Official Transcript of Proceedings
NUCLEAR REGULATORY COMMISSION

Title: Advisory Committee on Reactor Safeguards
 Radiation and Nuclear Materials Subcommittee

Date: Wednesday, March 2, 2016

The purpose of this meeting is to receive information briefing on Staff's development of Draft NUREG/CR-7209, a Compendium of Spent Fuel Transportation Package Response Analyses to Severe Fire Accident Scenarios. The Subcommittee will hear presentations by and hold discussions with representatives of the NMSS Staff.

MacArthur Maze Fire

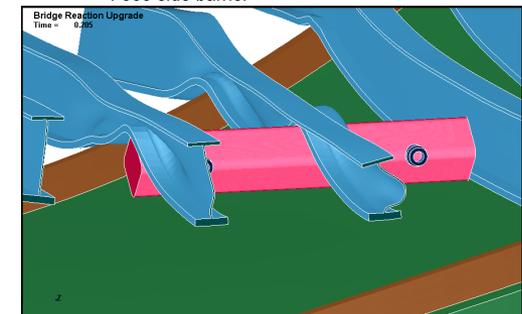
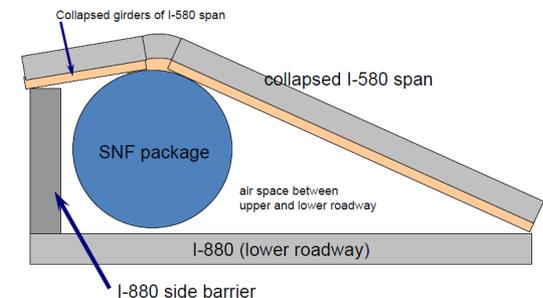
24 MEMBER SKILLMAN: Before you change that
25 image, would you explain what we see basically dead

5 I'd like to point out the top picture
6 on the right. This picture represents the post-
7 collapse situation where the I-580 span covers the
8 GA-4 package and hinders the removal of heat during
9 the post-fire cool down. And for the post-fire cool
10 down period, the results show a peak cladding
11 temperature of 1,400 degrees Fahrenheit, and a high
12 O-ring temperature of 1,150 degrees Fahrenheit.

2 And as shown in the lower figure on the
3 right, relatively speaking the girders are thin and
4 somewhat weak at high temperatures, and so they're
5 the ones that actually deform on impact.

15
16 MR. BOROWSKY: Right, that's a good
17 question. There were a number of what I'll call
18 orientations that were analyzed. The image that you
19 see on the bottom right was the case where the
20 girders were what I'd call across the package. And
21 that was considered because in that particular
22 situation you actually have two girders contacting
23 the package just by the space between the girders.
24 But there were three other orientations considered;
25 one was, and this may be kind of what you're
